Subject: Environmental Impact Statement – 43-61 Turner Road Data Centre (SSD-68013714)

CPHR advice on EIS – 43-61 Turner Road Data Centre (SSD-68013714)Documents Reviewed

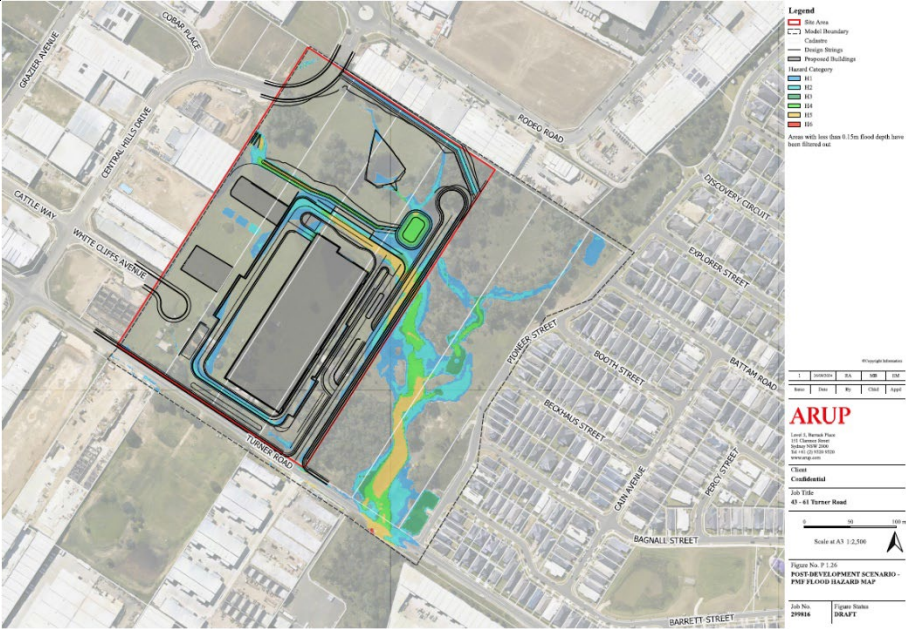
2.	<i>PMF flood impacts on adjacent areas</i>	<p>In the event of a PMF, the flood hazard at the downstream adjacent property increases from H2 to H4, as shown in the figures below.</p> 
----	--	---

<p>Recommended action:</p> <p>2. CPHR requests the proponent consult with the owner of the affected downstream property.</p>
	<i>Extent and Timing</i>	Pre-determination
